Notice of Determination

Project Title: Quiota Creek, Fish Passage Enhancement Projects

CACHUMA OPERATION AND MAINTENANCE BOARD FISH PASSAGE PROJECTS ON QUIOTA CREEK CROSSINGS

ADDENDUM TO THE EIR/EIS FOR THE LOWER SANTA YNEZ FISH MANAGEMENT PLAN AND CACHUMA PROJECT BIOLOGICAL OPINION FOR SOUTHERN STEELHEAD TROUT-FINAL EIR

Figure 3: Preliminary drawings of the bottomless-arched culvert, an example prepared for Crossing 6.

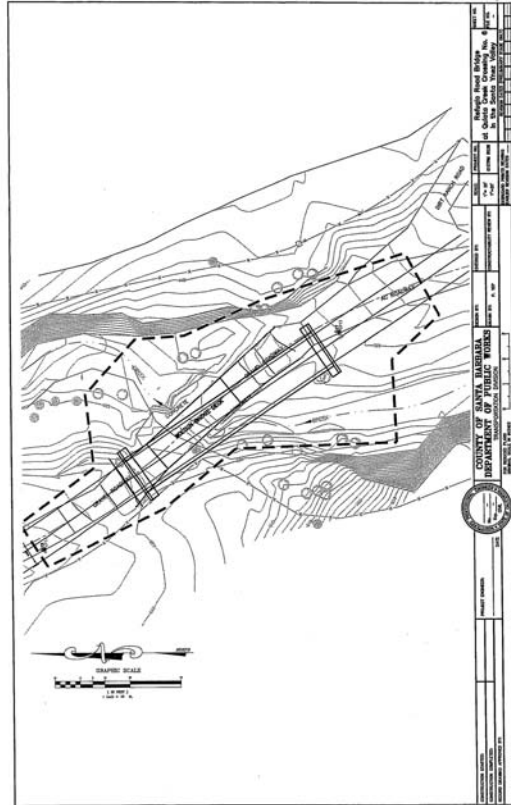
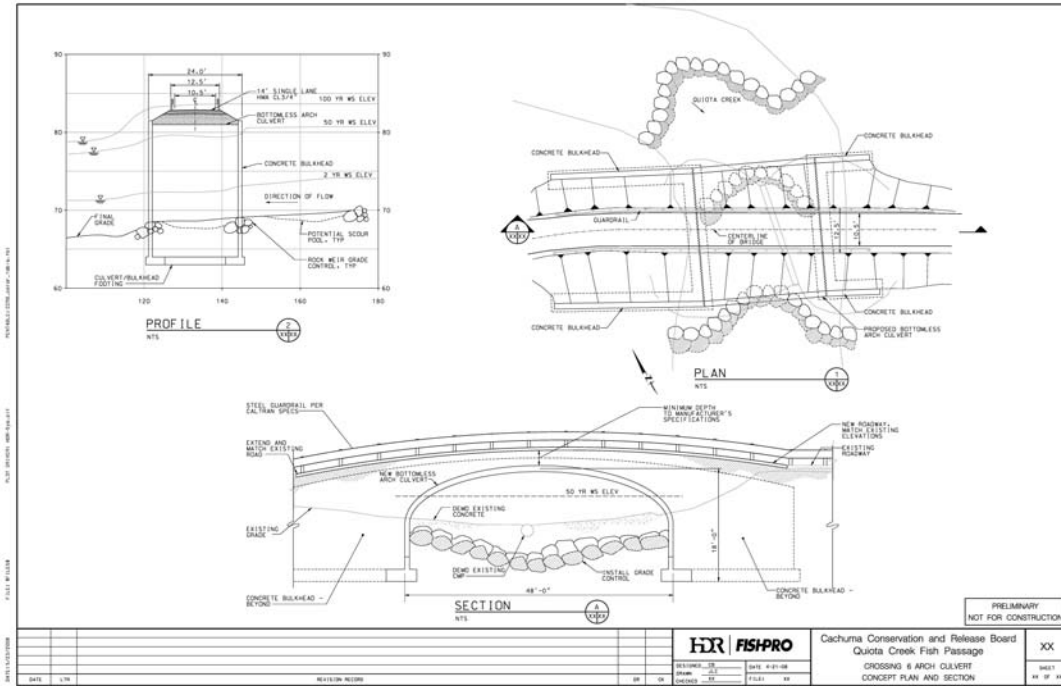
The primary objective of this Addendum is to add a third alternative for Projects #13 and #14 of the EIR/EIS, with each being an alternative design for the other. The project description evaluated in the EIR/EIS for Project #13 proposes permanent bridges be constructed on Crossings 2, 6, and 8 on Quiota Creek (Figure 1), and for Project #14 a rock riffle fishway for Crossings 3, 4, 5, 7, and 9 (Figure 2). This Addendum adds a third alternative, a bottomless-arched culvert, which could be constructed rather than a bridge or rock riffle fishway (Figure 3). The bottomless-arched culvert has the same benefit for fish passage, flood conveyance, and road safety as a bridge with comparable environmental impact (Figure 4) within the construction footprint, plus would be a superior design compared to a rock riffle fishway for fish passage and road safety. In addition, the landowners prefer the bottomless-arched culvert to the bridge due to its more subtle appearance and less visual impact.

Section 2.7.3 describes a rock fishway design to provide passage that would have a larger footprint than a bridge or a bottomless-arched culvert. Thus, between the two alternative designs presented in the EIR/EIS, the footprint of a bottomless-arched culvert and the potential environmental impacts would be the same as a bridge, hence would be within CEQA coverage for Projects #13 and #14 on Quiota Creek.

The existing low-flow crossings (Arizona Type crossings) or temporary wooden bridges sitting on top of damaged and abandoned low-flow crosses would be removed and would be replaced by bottomless-arched culverts that allow far superior fish passage, flood conveyance, and road safety to the existing condition. Most of the inlet culverts at the nine crosses are currently buried and all stream flow passes either over the concrete apron or under the damaged low-flow crossing. Under this third alternative, bottomless-arched culvert foundations and wing walls, bank stabilization materials upstream and downstream, road fill, and road approaches would be similar to a bridge, both providing a naturalized stream channel that would enable fish friendly passage upstream and downstream while improving road access and safety. The resulting

structure would be designed to convey the 50-year flood (with one foot of freeboard) and would need to withstand the 100-year flood event over the entire structure (CCRB, 2007). The bottomless-arched culvert would provide geomorphic continuity with the adjacent stream reaches such that channel degradation or erosion would be minimized and similar to the permanent bridge design. A bottomless-arched culvert has a diameter that is typically equal to or greater than the width of the natural active channel and is designed to allow for natural stream channel slope and configuration throughout its length while minimizing debris build up at the culvert inlet.
